# Access Compliance Report

## Public Rights-of-Way

### (Curb Ramps)

Intersection ID: 15813	Main Street: QUEENS_RD_WEST	Cross Street: ROLSTON_DR	Location:	N
ADA ID: 4341238FF88D	Ramp Type: MedianPerp	Initial Pass/Fail: Fail	Overall Compliance: No	Severity Score: 12.5
Codes/Mitigation Info/Possible Solution		Field Measurements/Component Compliance

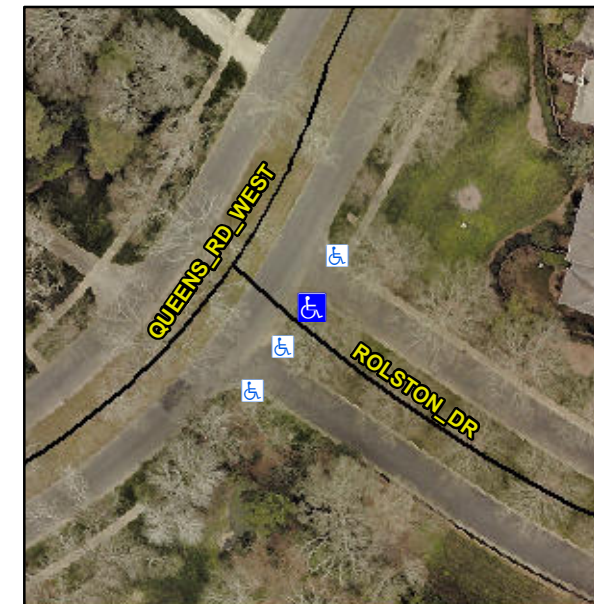
**Not Found, R304.5.3**

Compliance	Description	Data	Compliance	Description	Data
N/A	Ramp Length (in)	36.0	Yes	Ramp Slope (%)	5.2
Yes	Ramp Width (in)	48.0	No	Ramp XSlope (%)	5.6
N/A	Flare Type LT	N/A	N/A	Flare Type RT	N/A
N/A	Flare Slope LT (%)	N/A	N/A	Flare Slope RT (%)	N/A
N/A	Flare Traversable LT?	N/A	N/A	Flare Traversable RT?	N/A
N/A	Landing Length (in)	N/A	N/A	DWS Provided?	N/A
N/A	Landing Width (in)	N/A	N/A	DWS Contrast?	N/A
N/A	Landing Slope (%)	N/A	N/A	DWS Length (in)	N/A
N/A	Landing X Slope (%)	N/A	N/A	DWS Full Width?	N/A
N/A	Landing Curb? (Y/N)	N/A	N/A	DWS Offset (in)	N/A
N/A	Shared Landing?	N/A			
N/A	Gutter Ponding?	N/A	N/A	Gutter Slope (%)	N/A
N/A	Gutter Lip Ht (in)	N/A	N/A	Gutter X Slope (%)	N/A
N/A	Painted X Walk1?	No	N/A	Painted X Walk2?	N/A
	X Walk 1 Direction	To NE		X Walk 2 Direction	N/A
N/A	X Walk 1 Width (in)	N/A	N/A	X Walk 2 Width (in)	N/A
	X Walk 1 Slope (%)	1.4		X Walk 2 Slope (%)	N/A
	X Walk 1 X Slope (%)	3.4		X Walk 2 X Slope (%)	N/A

**Remove & Replace Entire Ramp.**
